# SERVICE BULLETIN #122

04/14/14

## 8522 Spoke Wheel

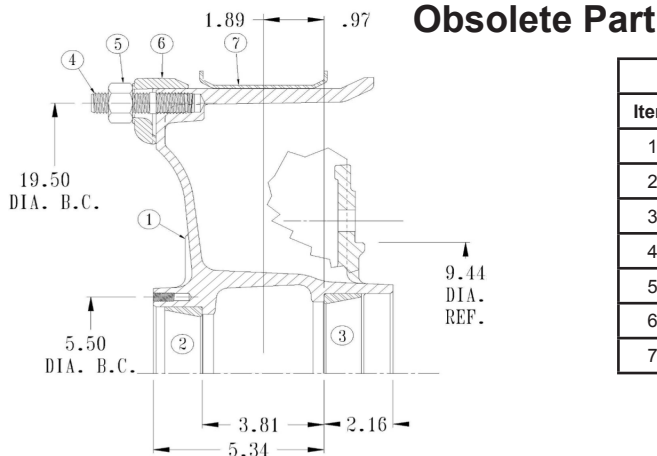
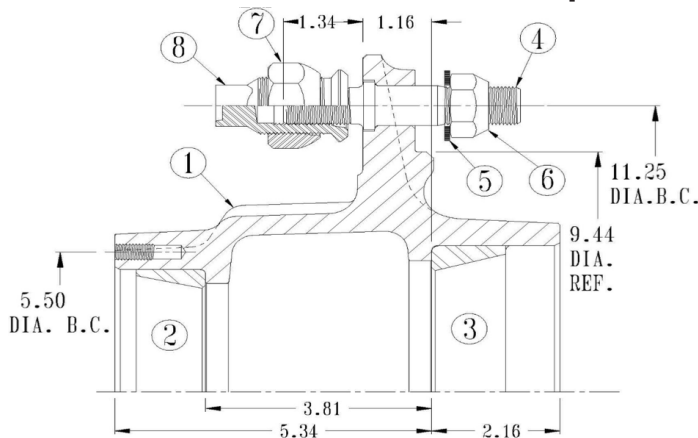
Upon depletion of inventory, the 8522 spoke will become obsolete with no direct replacement. We do however recommend a replacement: the 10-stud 1221 hub. This requires changing brake drums, changing to a disc hub, and changing to disc wheels instead of demountable rims. If you have any questions, please contact the Webb Engineering department via email to [engineering@webbwheel.com](mailto:engineering@webbwheel.com) or call 256-736-6356.
